**BMW E36 / Z3 / Z4**
Strut mount 87-386-A*Fig. 1: New Version**Old Version***NOTE**

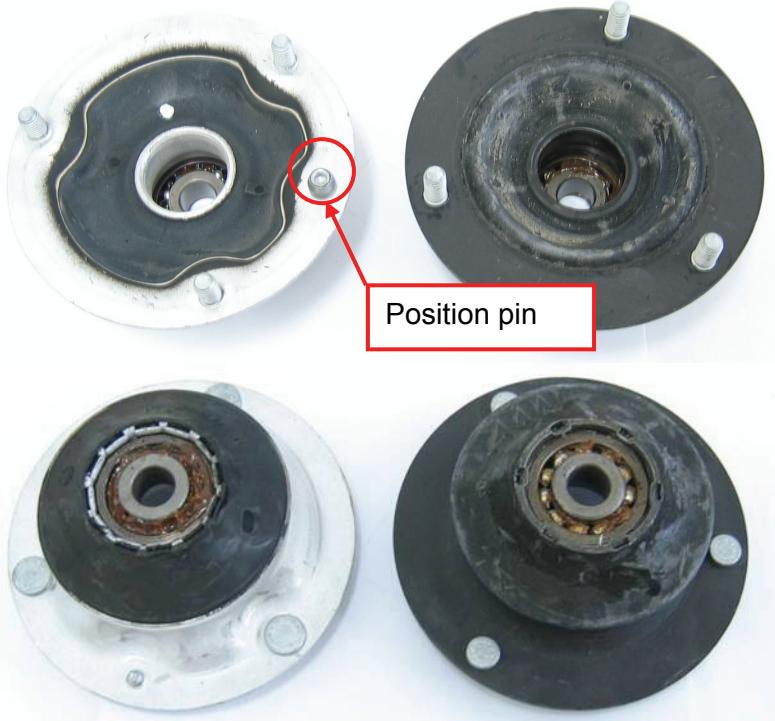
The damper mount on front axle was replaced on the BMW models E36 and Z3. In addition to the visual difference, a position pin is located at the upper attachment surface. This pin is needed only in the Z4 model. Therefore, it **must** always be removed in the models **E36 and Z3**.

Unscrew the position pin to remove it.

If the pin is not removed in the models E36 and Z3 fastening is impossible.
